CHANGE ORDER NUMBER: 2HNTB Corporation
Round Rock1. CONTRACTOR: QA Construction Services Inc.Project: Great Oaks WLRelocation2. Change Order Work Limits: Sta. 502+25 to Sta. 512+27

CHANGE ORDER NUMBER: 2

Project # Great Oaks WL Relocation-3185

Change Order No. 2

WILLIAMSON
COUNTY
1848

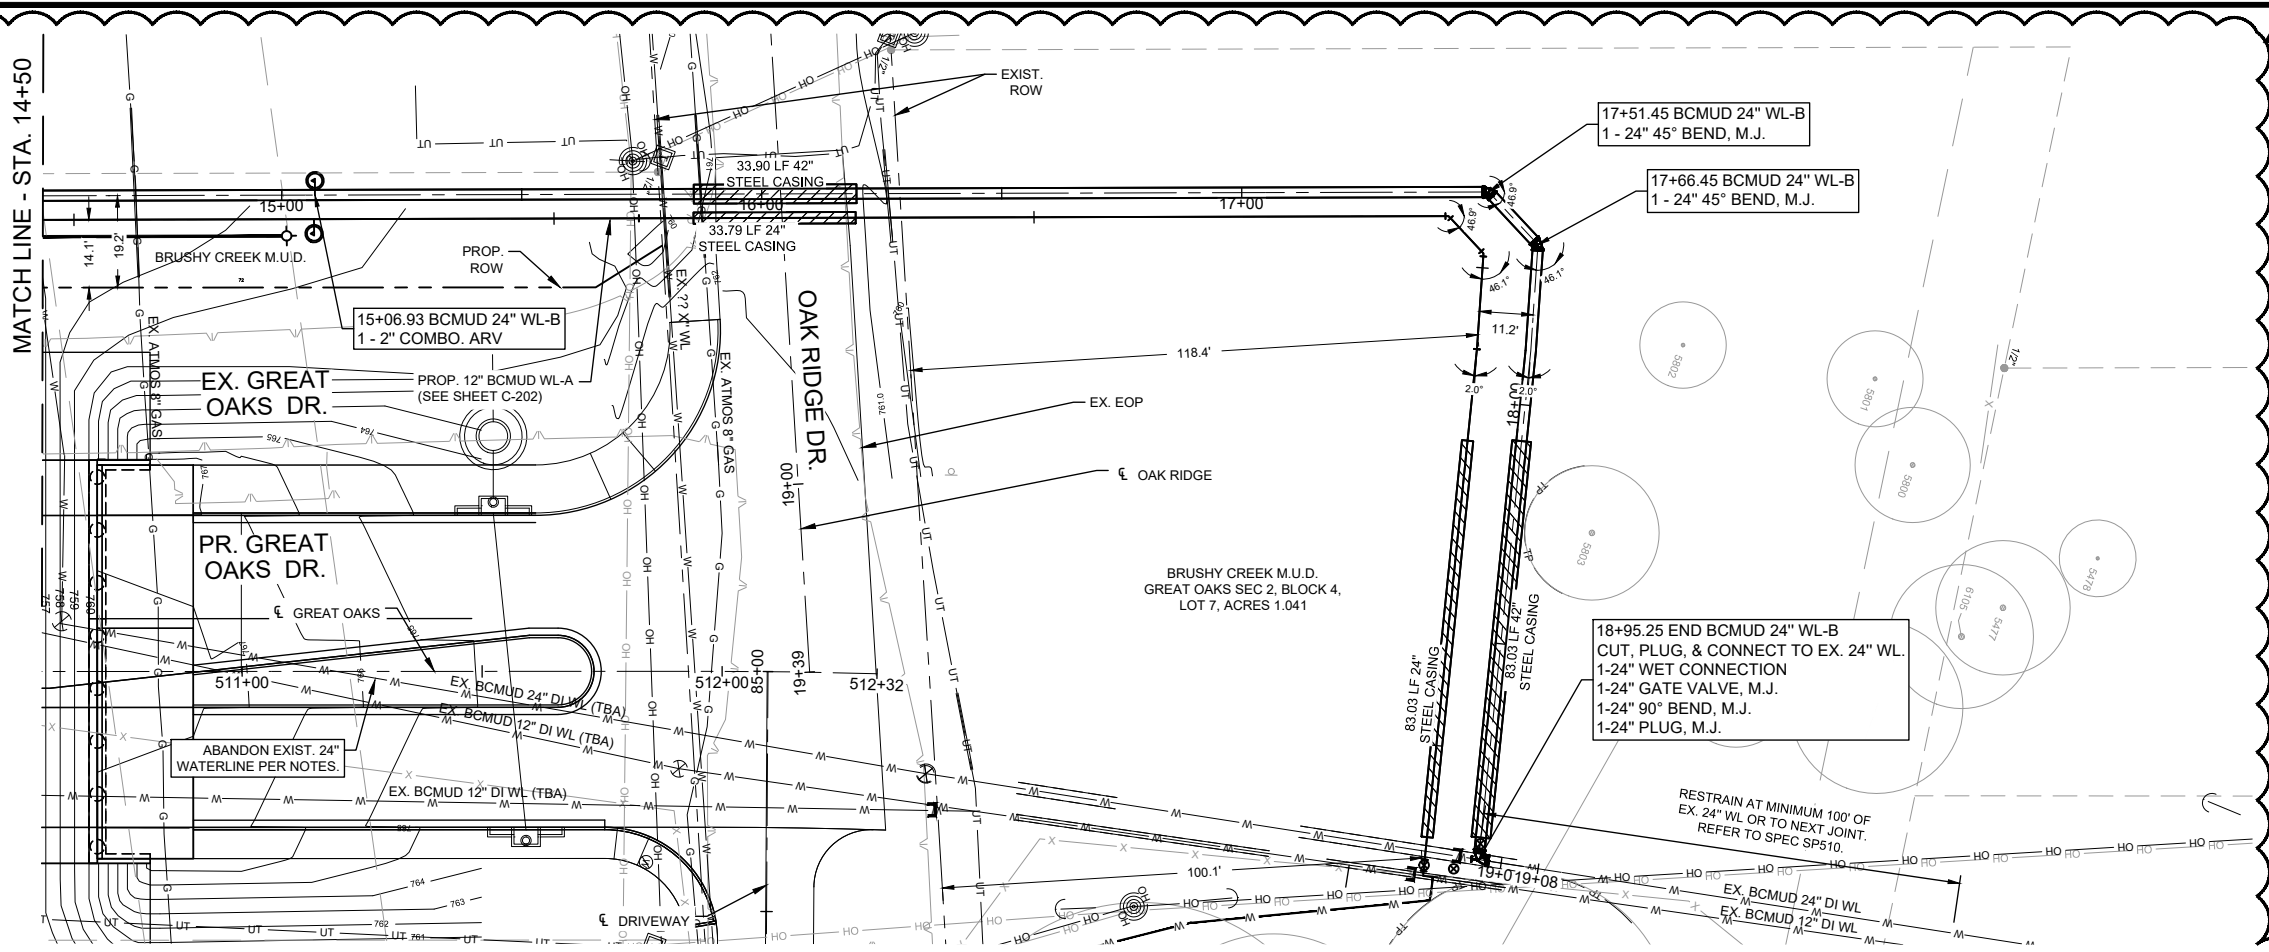
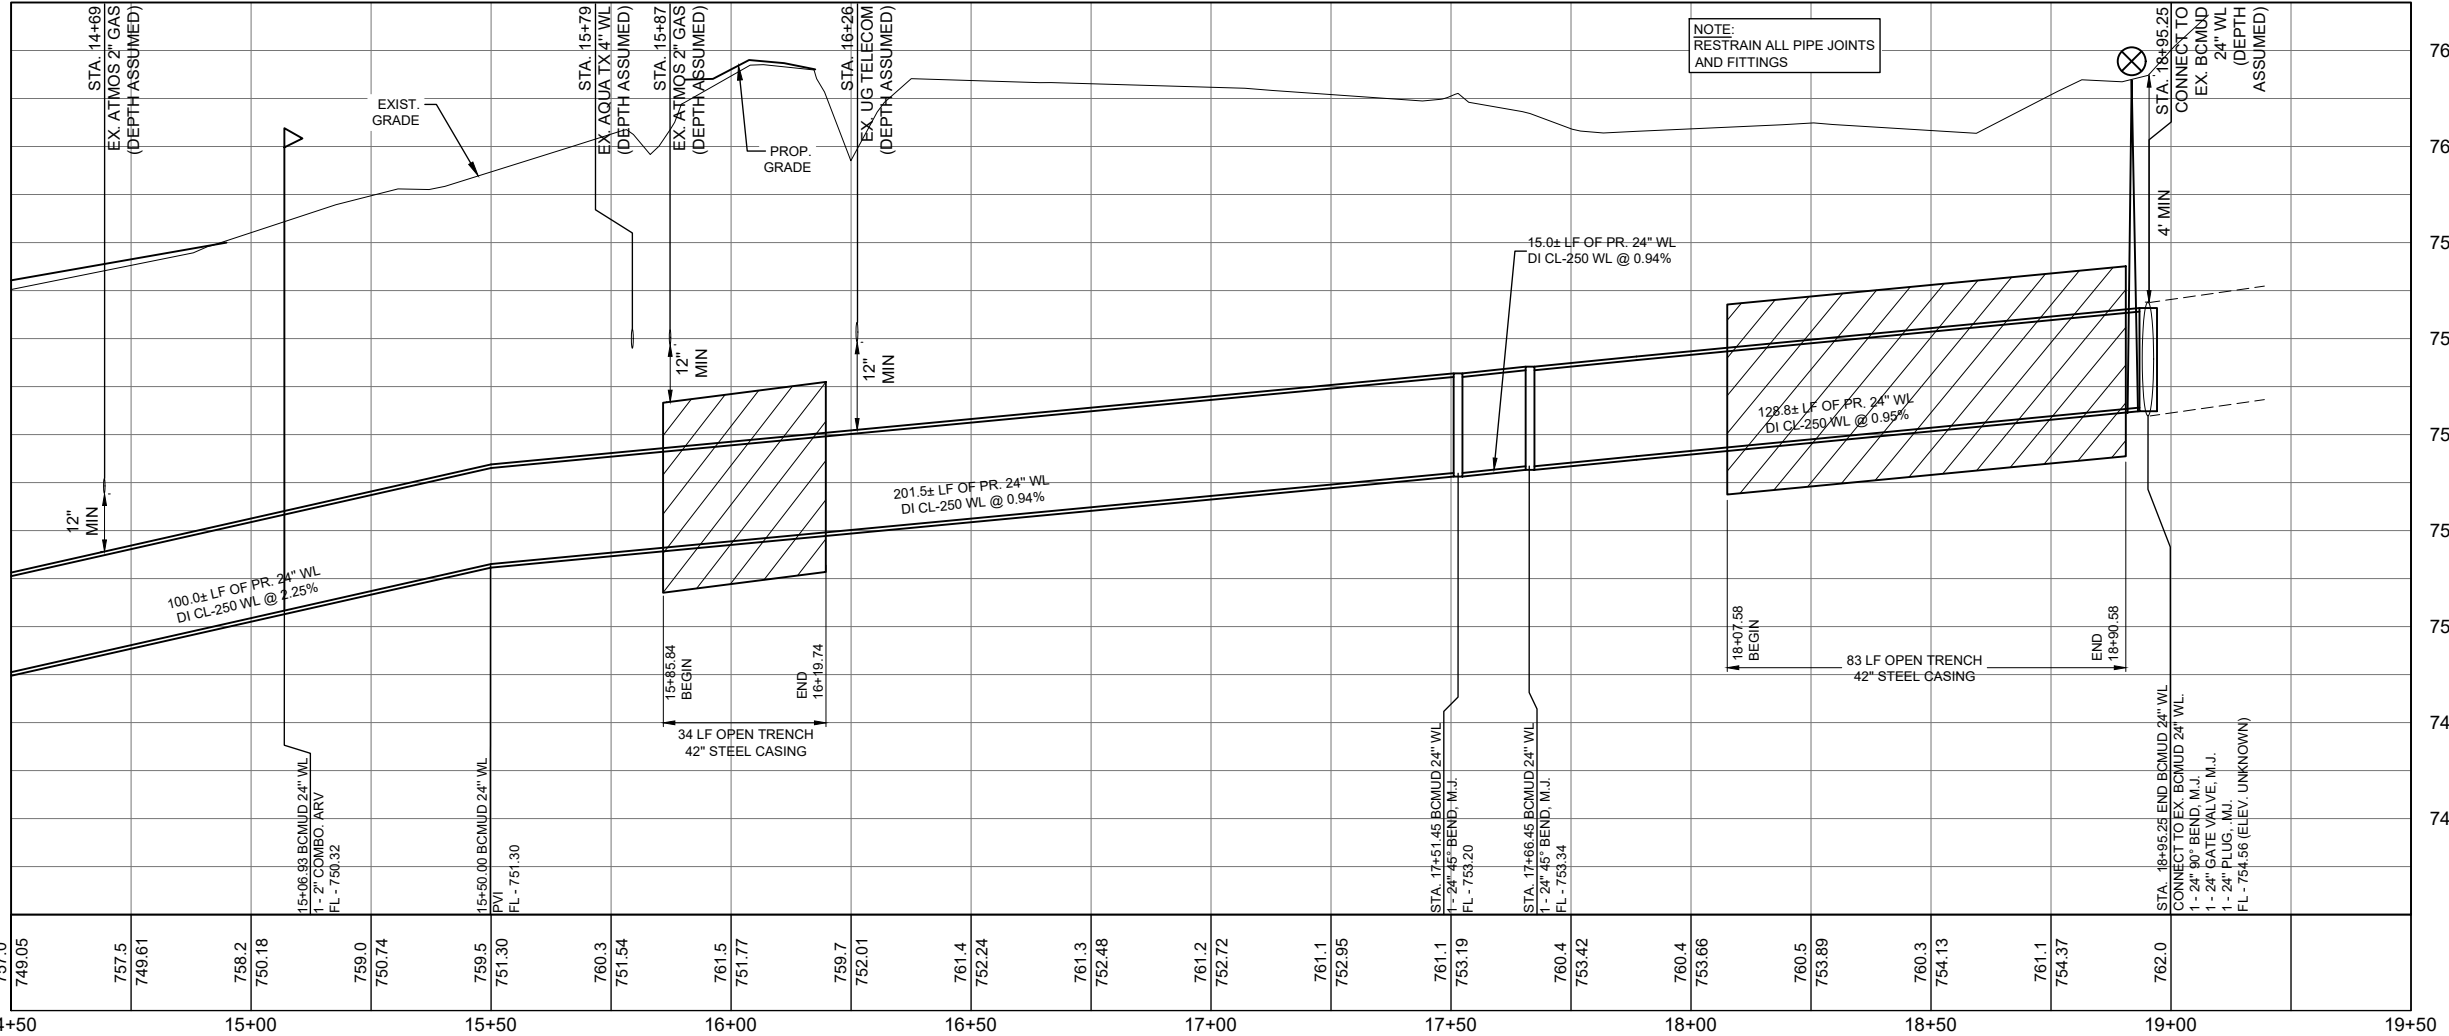
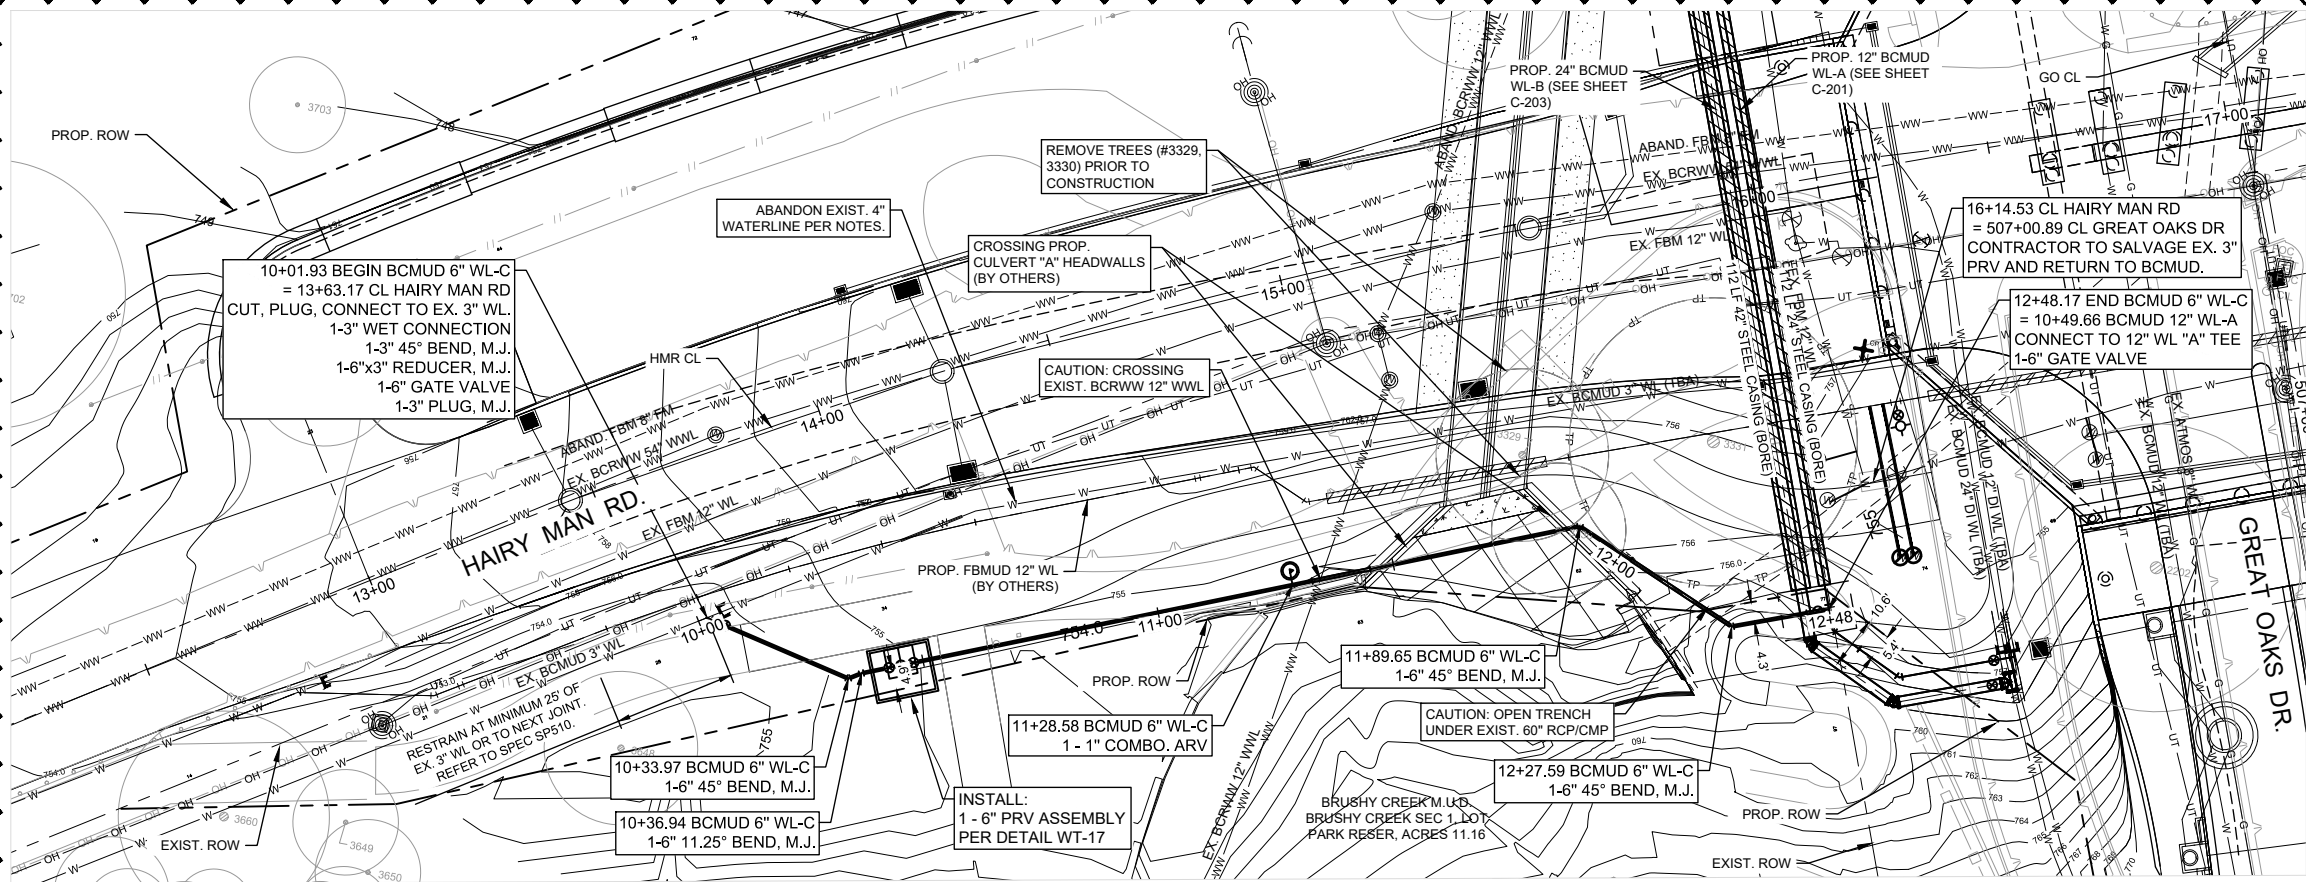
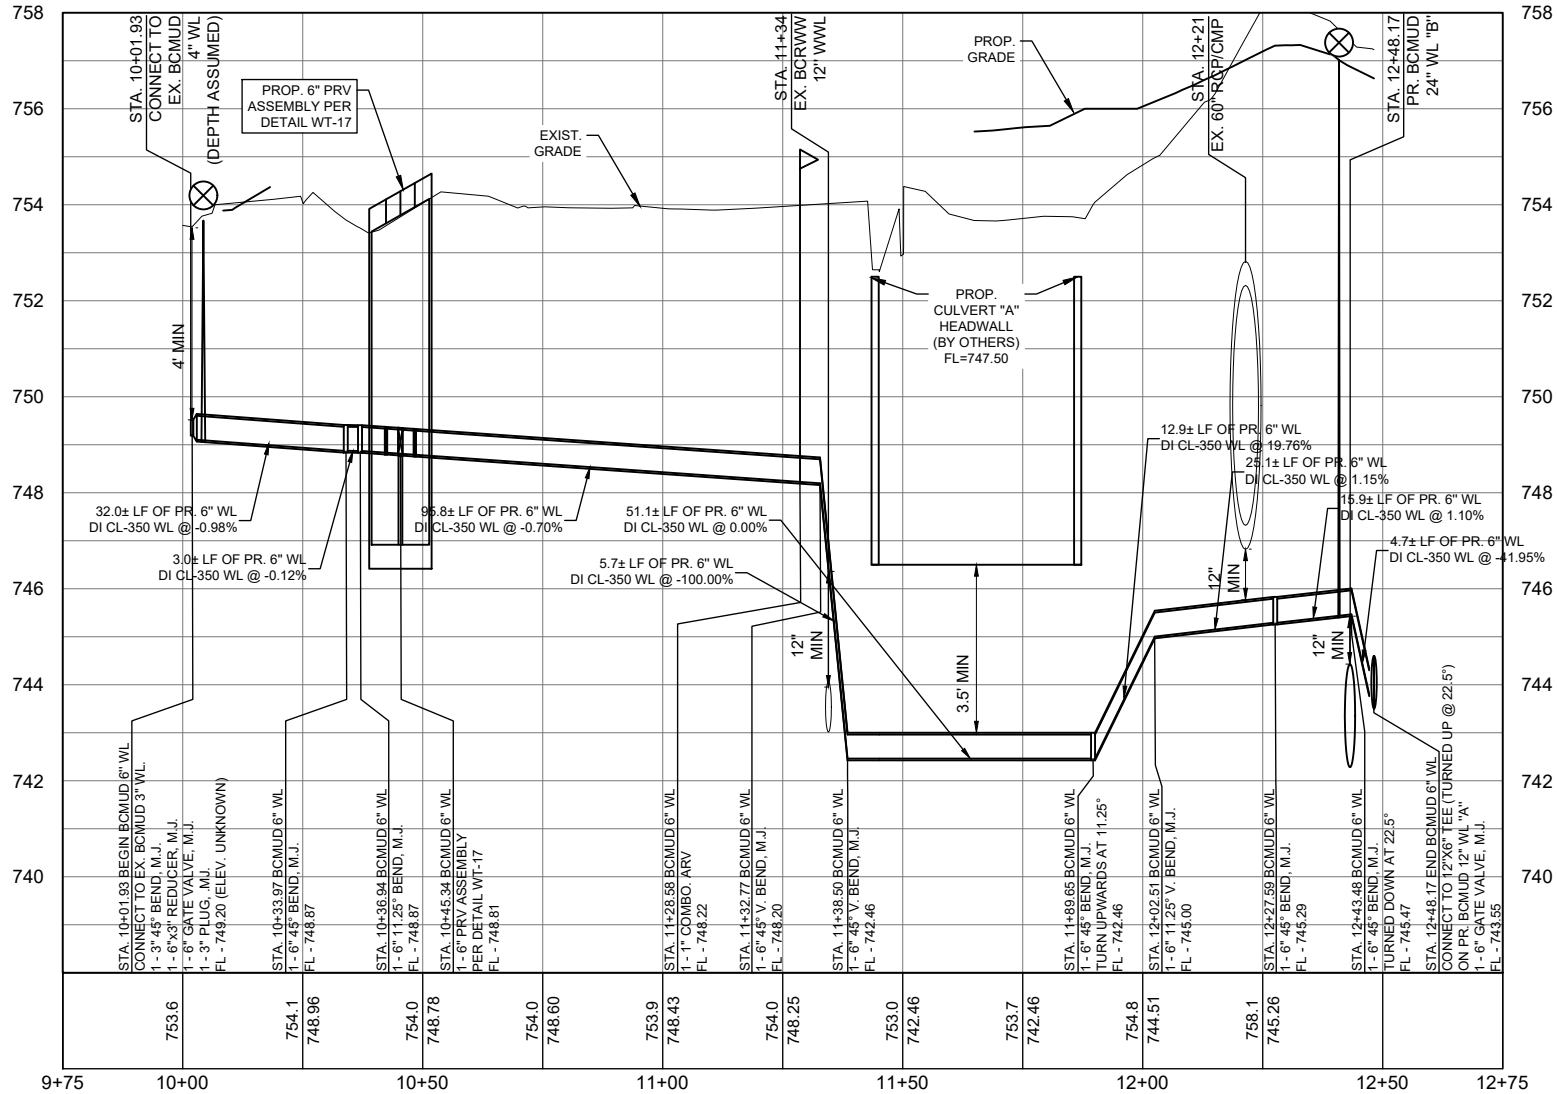
This Change Order adds revisions to the Brushy Creek MUD water line design that did not make it into the original plans. These revisions include changes requested by the Brushy Creek MUD (BCMUD) to the water line alignment for the 12" and 24" pipe north of Oakridge Drive. The BCMUD also requested to change the size of Water Line C from 4" to a 6" water line, add pipe restraint on the existing 3" water line and the addition of a 6" Pressure Release Valve Assembly (PRV). These changes are necessary, because the specification for minimum size water line is 6 inches.
